#### COA-081843-2020 5.

2204 West Grace Street

Commission of **Architectural Review**

STAFF REPORT

Figure 4. 2204 West Grace Street, rear parking area.

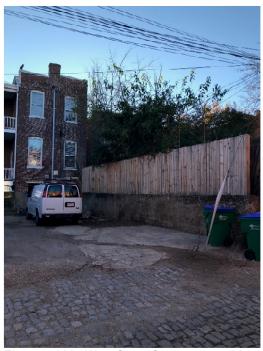
Staff finds that the proposed new patio area at the rear is consistent with the property and the district, and will only be visible from the alley. Staff recommends approval of the rear patio.
Paint, Historic Masonry #1, pg. 63	Do not paint historic brick or stone masonry that has not previously been painted. Painting previously unpainted masonry is historically inaccurate and is not permitted.	The application states that the concrete curbing at the sidewalk will be painted. Staff recommends any unpainted concrete remain unpainted and colors be submitted to staff for administrative approval.
Guidelines for Administrative Approval of Handrails and Porch Railings, #1	Staff may approve up to two metal handrails for any type or location of porch, deck, or stoop as long as the railings are a simple wrought iron design and installed in such a way as to have a minimum impact on historic materials. Such railings shall be painted black, black green, or a color complementary to the primary structure on the property.	As details for the proposed handrail at the rear stairs were not provided, staff recommends specifications for the proposed handrail be submitted for administrative review and approval.

Standards for Site Improvements, Fences & Walls	<ol> <li>Rear-yard privacy fences should mimic traditional fence designs.</li> <li>Wooden fences should be repaired and painted as needed. Existing picket designs should be matched when replacement is</li> </ol>	The plans state that screening will be added to the trash enclosure at the rear. As details were not provided, staff recommends final specifications for the enclosure be submitted to staff for administrative approval.

- The front steps be repaired or replaced in-kind with new concrete to match the existing.
- The rear stairs be constructed of smooth, undecorated concrete.
- The concrete walkway to the side yard that is visible from the street be replaced in-kind with new plain concrete.
- Any unpainted concrete remain unpainted, and colors be submitted to staff for administrative approval.
- Specifications for the proposed handrail on the rear stairs be submitted for administrative review and approval.
- Final specifications for the trash enclosure be submitted to staff for administrative approval.
